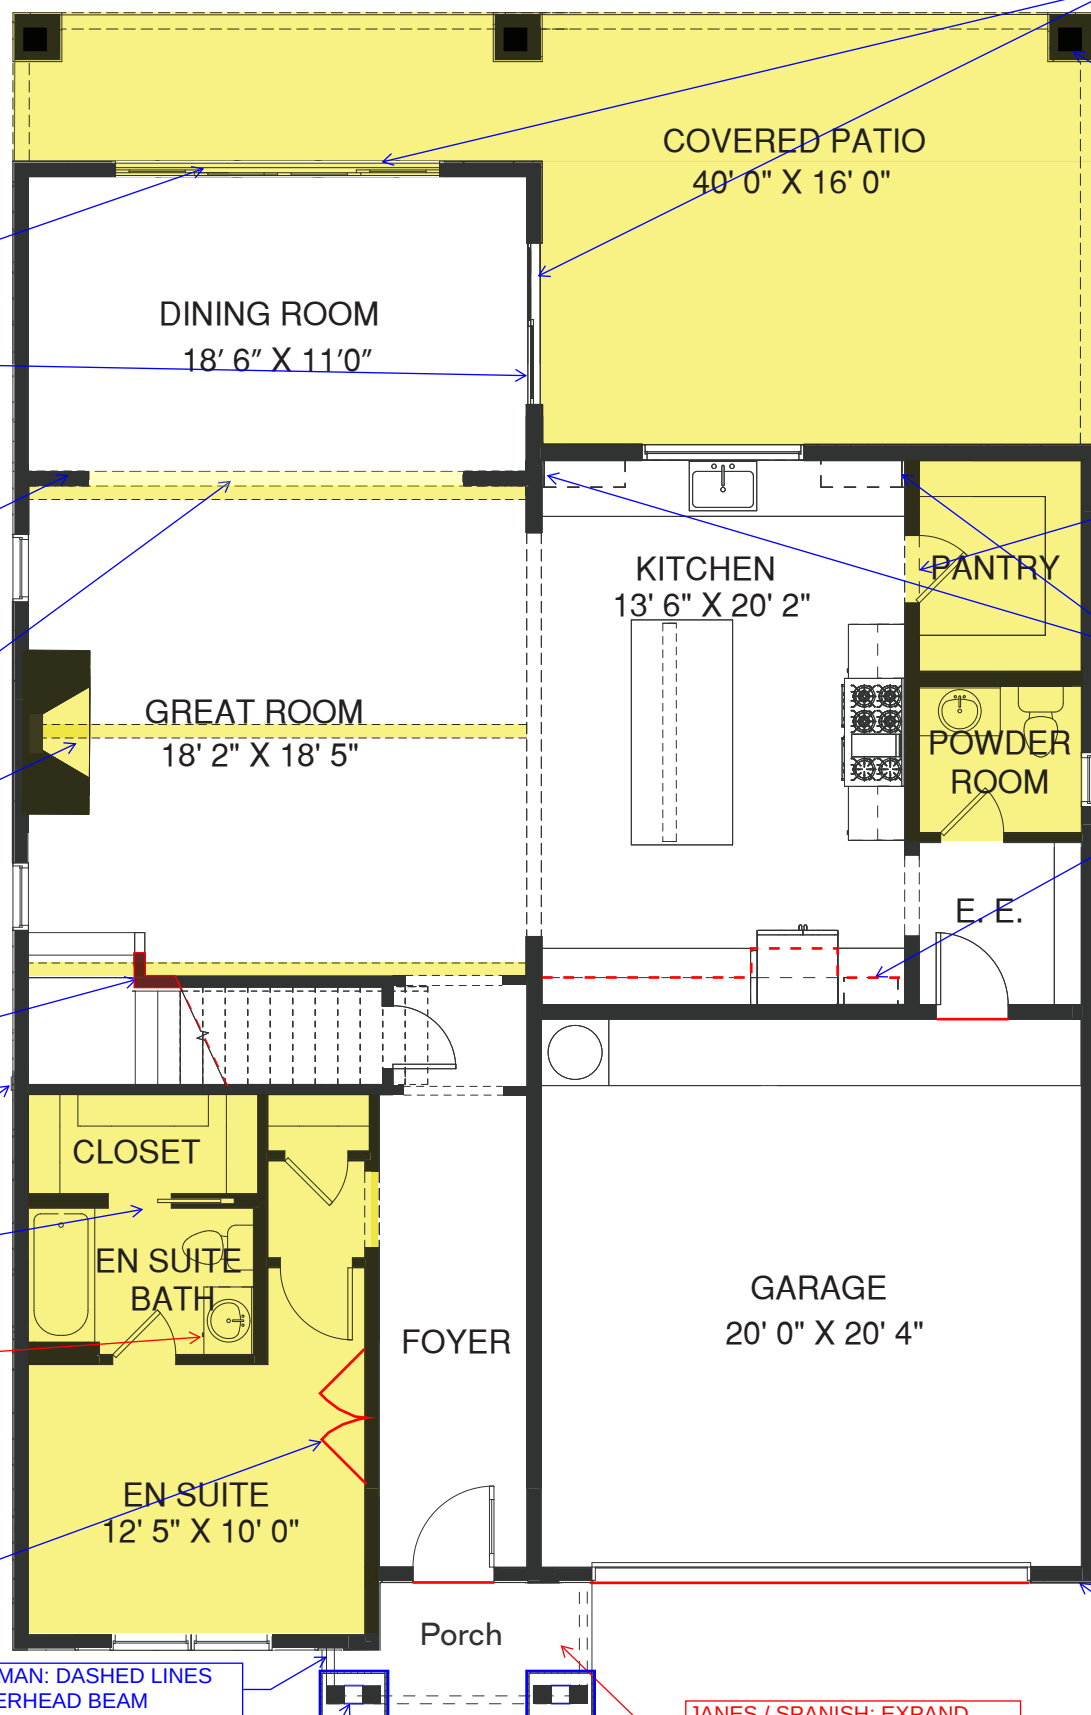
KE BASE WALL
INNER FILL
NOT BLACK;
HATCHES TO BE

ERIOR LINE OF
L TO ALIGN WITH
FACE OF WALL;
TERIOR SILL LINE

DASHED LINES FOR
SE (AT THIS
WHEN
001" IS NOT
EXCEPT FOR ONE
ED LINE
ING FLAT CEILING
LT IN GREAT ROOM

OUT BELOW
OPTION LAYER SO
AUX BEAMS
D CEILING PEAK

HATCH BACK TO
OF STAIR

ELETE LINES
OUT EXTERIOR

ON'T NEED TO
BATH 2 / CLOSET /
CHANGE)

E001" DELETE
MP IN FRONT OF

R001" SHOULD
O FLEX ROOM

CRAFTSMAN: DASHED LINES
FOR OVERHEAD BEAM

CRAFTSMAN: DELETE SOLID
INNER LINES WHERE
HIGHLIGHTED

CRAFTSMAN: EXTRA
RECTANGLE / HATCH AROUND
INNER

ADD ROOM IN PARENTHESIS
TO CEILING BEAM OPTIONS (IN
LAYERS) TO HELP NOTE
GREAT ROOM VS. PRIMARY
BED

SIMPLIFY SL
FEWER LINE
RECTANGLE

"ADDPWR
DASHED LI

DELETE EN
SIMPLIFY U
DASHED LI

EXTEND UP
FILL GAP, B
OVER FRID
DEPTH; CE
OPENING

EXPAN
WALLS
LINE, T

CHECK
TO .1 F

JANES / SPANISH: EXPAND
BLACK HATCH AT PORCH
COLUMNS/WALLS

ADD ROOM IN PARENTHESIS
TO CEILING BEAM OPTIONS (IN
LAYERS) TO HELP NOTE
GREAT ROOM VS. PRIMARY
BED

HARDWARE BELOW
ED LINES IN BASE

ED LINES IN BASE
ED LINE AT
001"; I THINK
O BY NOTE DIRECTLY

DELETE DOUBLE L
SHELF

REMOVE HARDWA
VANITY

"LNRYWD0001" MIS
AT REAR CORNER

EXTEND UPPER CA
OPTION ACROSS F
OF LAUNDRY

"LAUNDRY" NOT "L
ROOM"

EXPAND BLACK H
WALLS OUT TO EX
LINE, TYP. ALL EX
